Re: Residential development with infill affordable housing at 11 – 23 Rangers Avenue, Mosman (SSD-96272465)

We wish to lodge a submission objecting to this proposal.

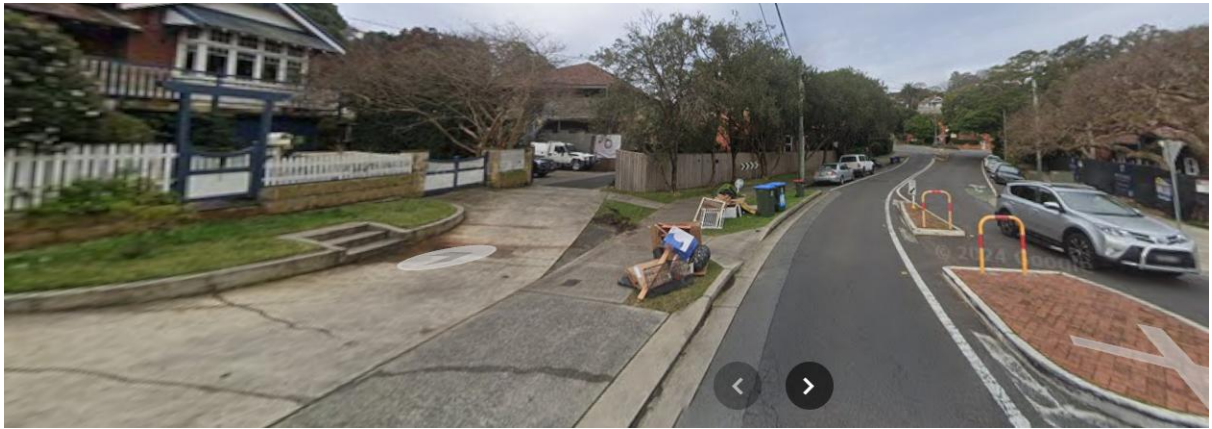
The Heritage Impact Statement's consideration of the Holt Estate HCA's value is grounded in falsehoods and obfuscation:

- At page 7, the HIS claims that "existing dwellings within the Holt Estate HCA towards (sic) do not offer views from the HCA towards Mosman Bay or the Sydney city skyline towards the site." This is incorrect, as even the VIA acknowledges that private view loss would occur from some properties on the southern side of Holt Avenue (refer VIA 7.3), which is further reinforced in the EIS at pages 66-67 and Figure 21.

Source: Google Maps

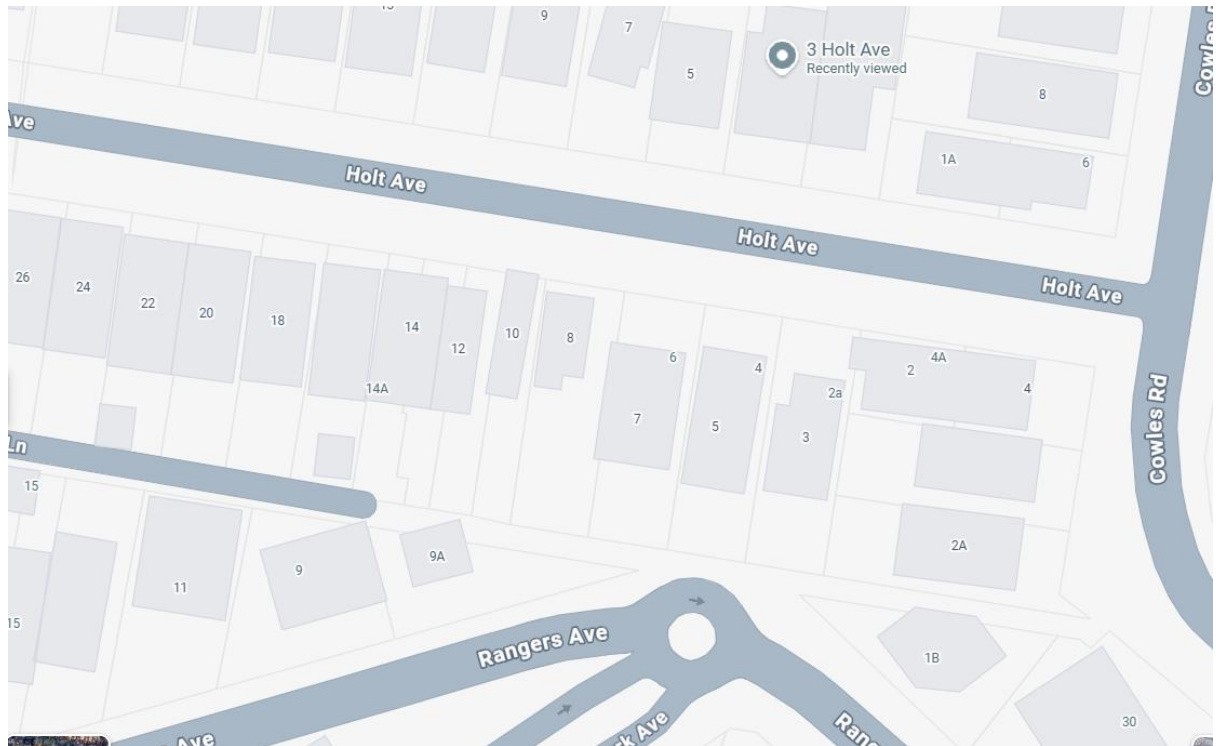
- On-street parking in Holt Avenue, which is already at a premium with commuters, tradies and residents jockeying for space, will worsen if the proposal goes ahead. Some houses in Holt Avenue have off-street parking provision for one car and some, including ours, have none. As the proposal intends to have pedestrian access to Bloxsome Lane, any overflow parking generated by residents and/or visitors to the site is likely to encroach on Holt Avenue in and around its intersection with Bardwell Lane. A shared

vehicle/pedestrian connection between Rangers Avenue and Cowles Road – see image and diagram below – would make the eastern end of Holt Avenue attractive to any overflow parking from the site. This is where we live and it is already difficult to find parking.
